## Planning Commission Staff Report

**Meeting Date:** May 24, 2021

**Description:** **Wildhorse Village, (Lot 1) SDSP:** A Site Development Section Plan, Landscape Plan, and Lighting Plan for the 8.6 acre tract of land located east of the future Burkhardt Place extension, south of Wild Horse Creek Road, and west of Chesterfield Parkway West.

DRAWING TITLE  
SITE LIGHTING  
CALCULATION PLAN  
DRAWING NO.  
**E2.100**

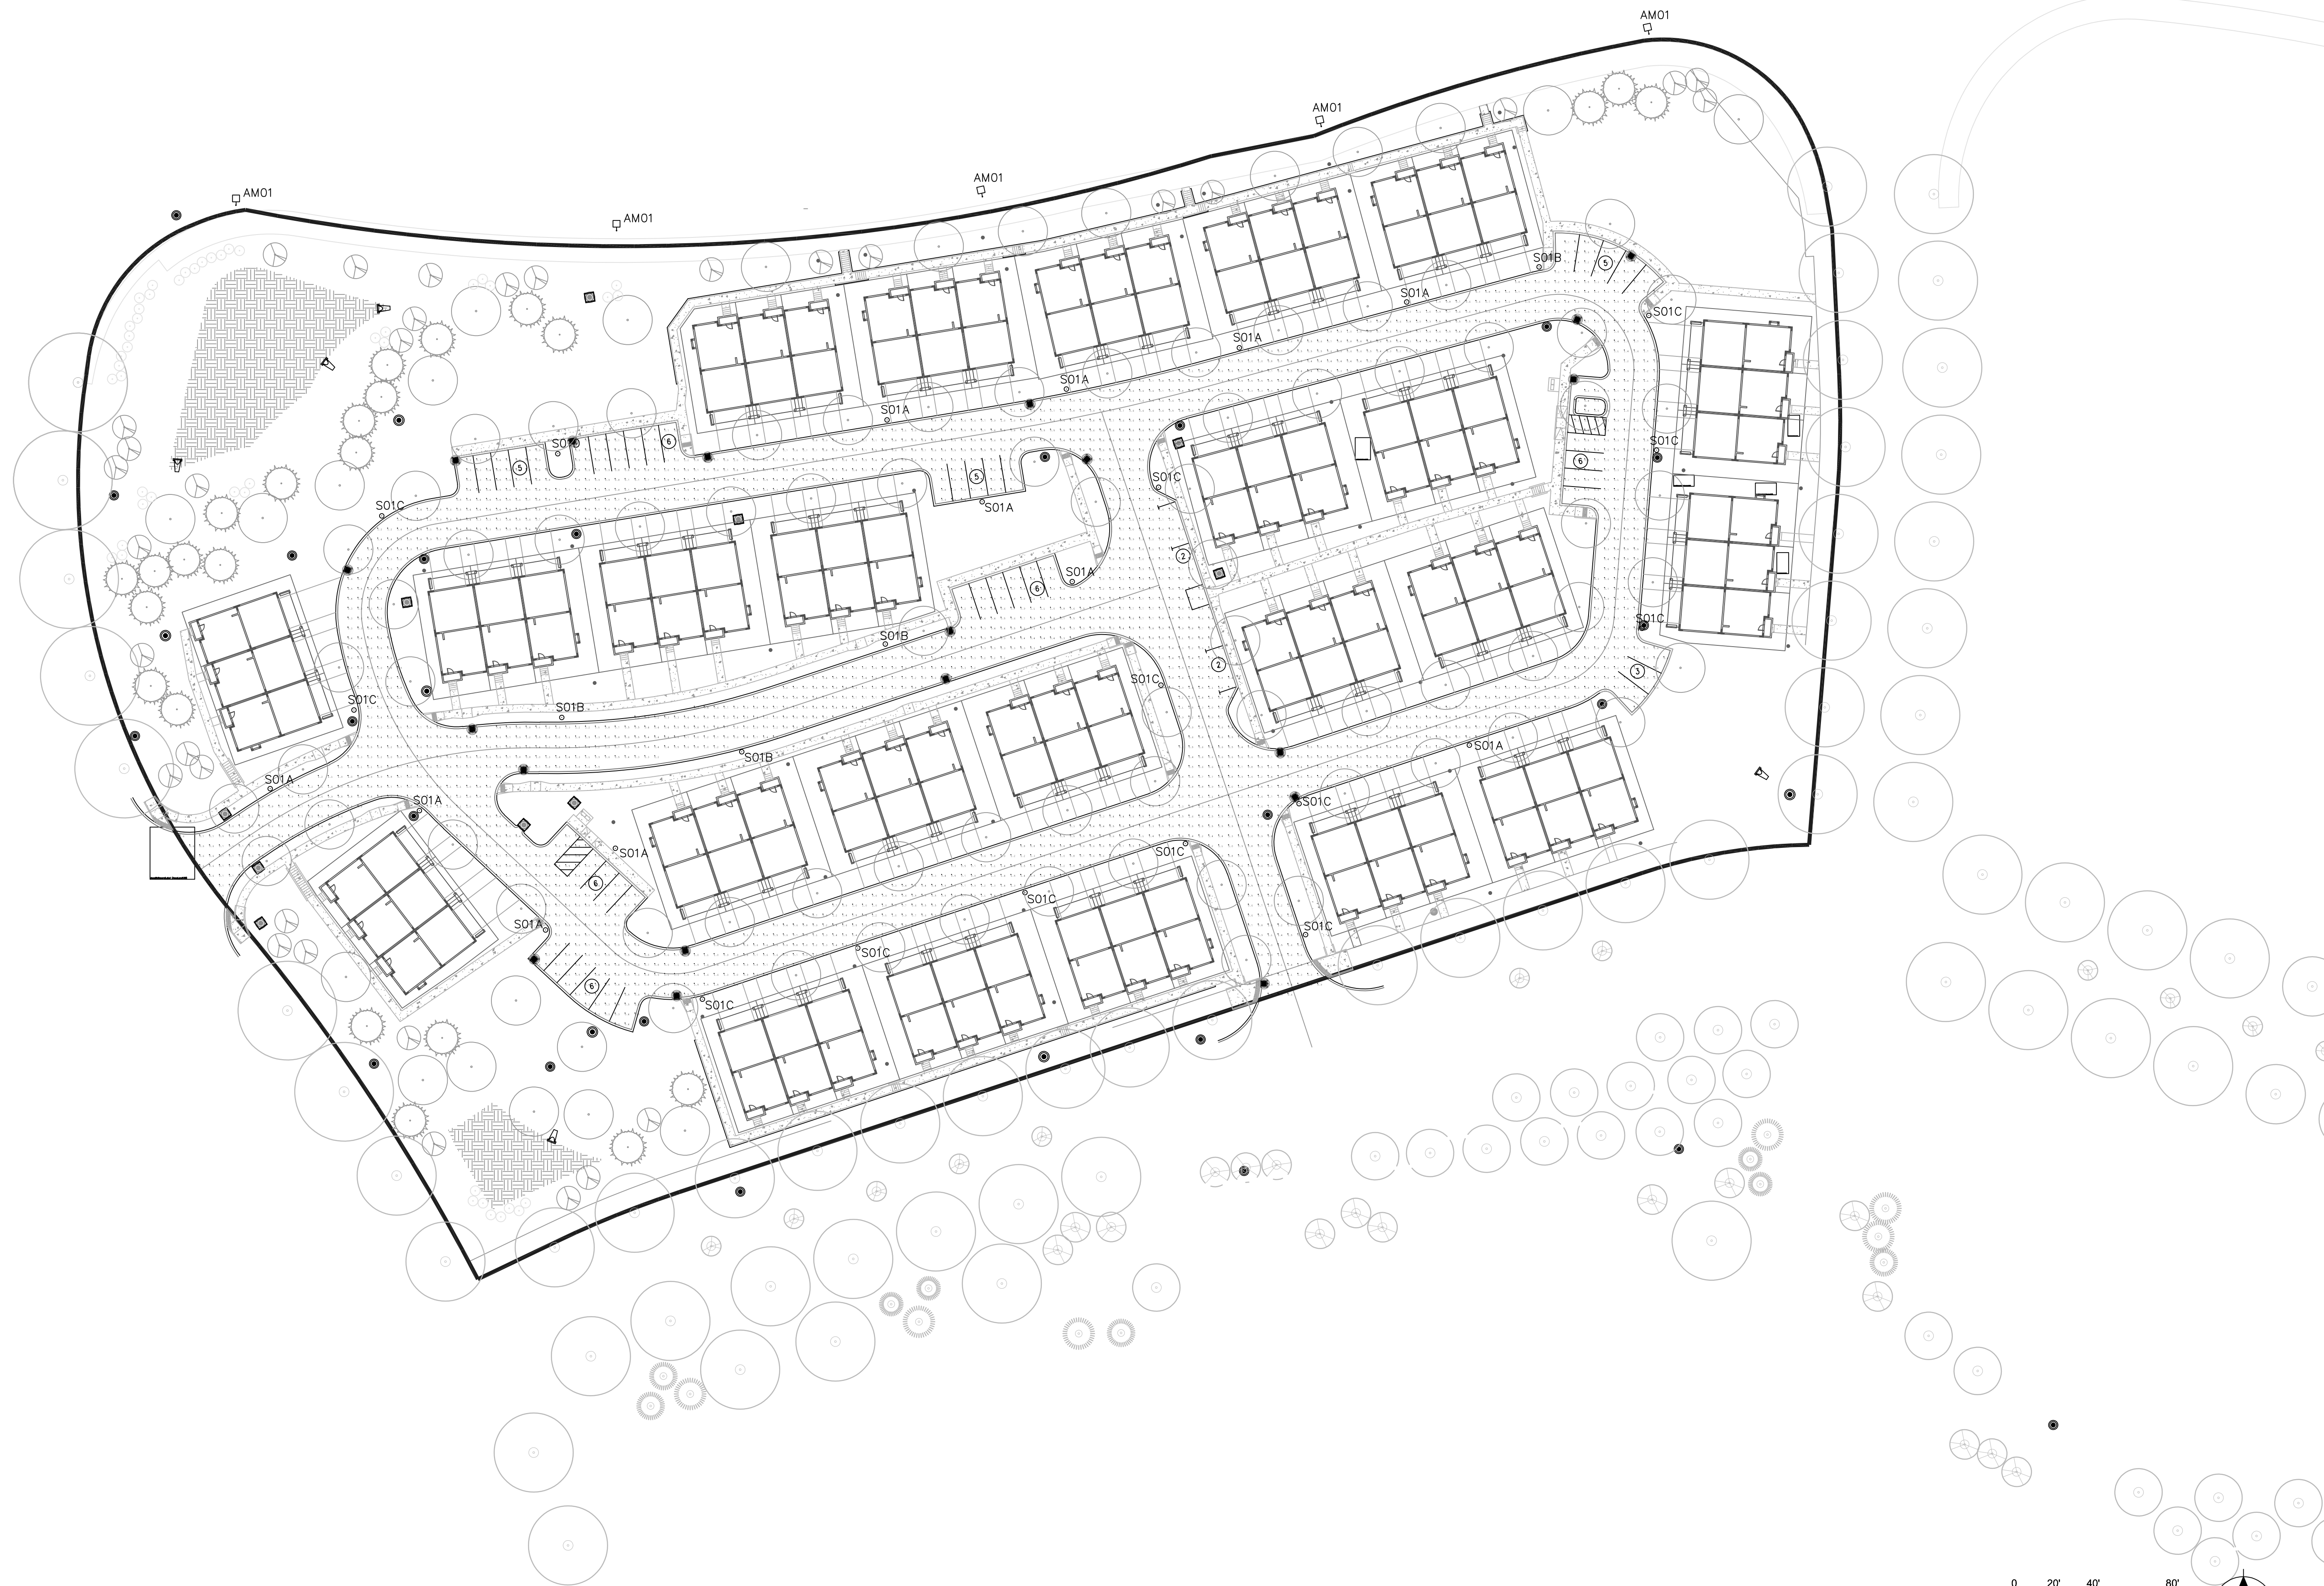
The internal roadway has a series of street lights. The fixture proposed matches the fixture approved within the Lighting Fixture Concept Plan for the development. The height of street lights is 16’8” and the maximum light level is 2.2 foot candles which conforms to the lighting standards of the City’s Unified Development Code.
